SUNDRY NOTICES AND REPORTS ON WELLS
Do not use this form for proposals to drill or to re-enter an abandoned well. Use Form 3160-3 (APD) for such proposals.

8. Well Name and No. FORTY NINER RIDGE UNIT/133H

Mewbourne Oil Company requests approval to make the following changes to the approved APD:

PECOS DISTRICT DRILLING CONDITIONS OF APPROVAL

3-String Design – Open Production Casing Annulus

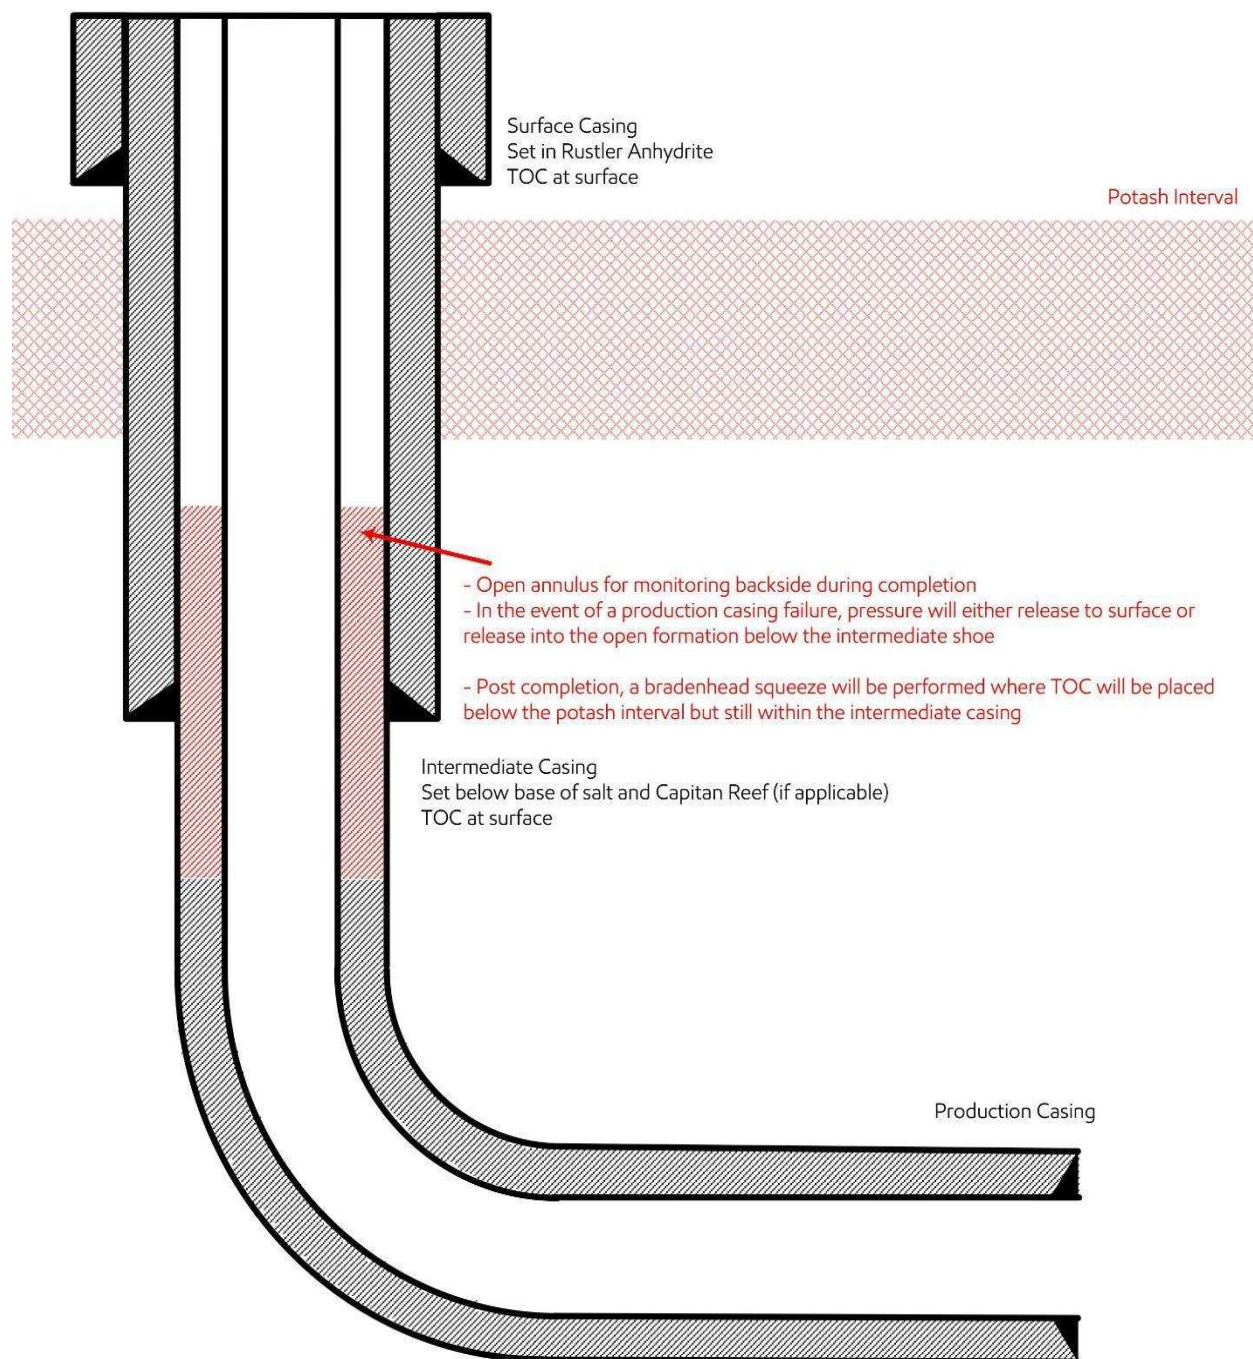
- i. A monitored open annulus will be incorporated during completion by leaving the 1st Intermediate Casing x Production Casing annulus un-cemented and monitored inside the 1st Intermediate String. Reference wellbore diagram.

- i. The top of cement in the Production Casing x 1st Intermediate Casing Annulus shall stand uncemented at least 500' below the 1st Intermediate Casing Shoe. Zero percent excess shall be pumped on the Production Cementing Slurry to ensure no tie-back into the 1st Intermediate Casing Shoe.

- ii. After Stimulation Operations have been concluded and no longer than 180 days after the well is brought online, the operator will be responsible for Bradenheading cement to ensure at least a 500' tie back has been established inside the 1st Intermediate (Salt String / Capitan String) but not higher than Marker Bed No. 126 (base of the Potash mining interval).

WELL LOCATION AND ACREAGE DEDICATION PLAT

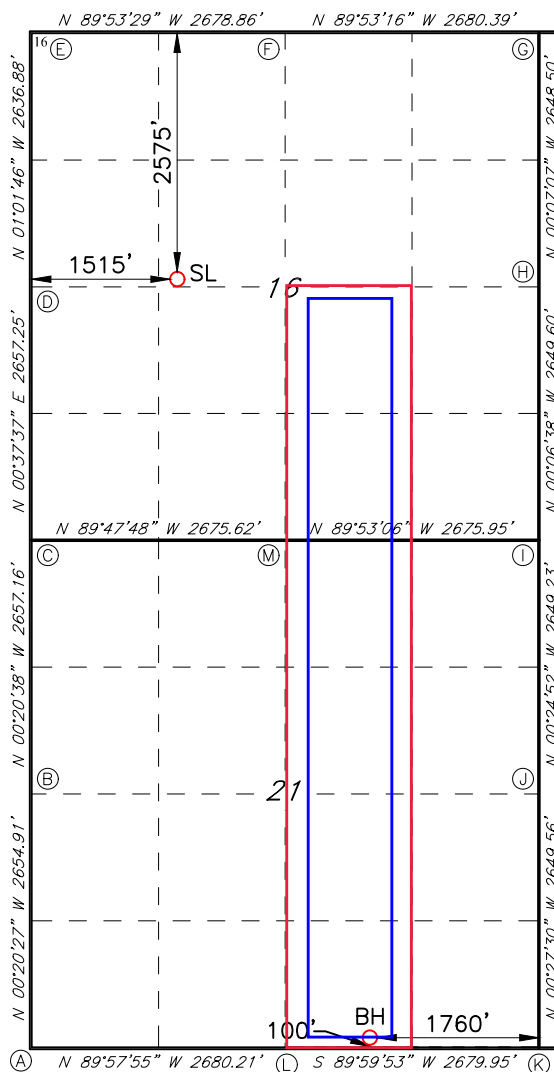
1) Change SHL from 2575' FNL & 1455' FWL, Sec 16, T23S, R30E to 2575' FNL & 1515' FWL, Sec 16, T23S, R30E

2) Change pool from Wildcat Wolfcamp (98268) to Forty Niner Ridge Bone Spring (24720) and target zone from Wolfcamp to Harkey shale
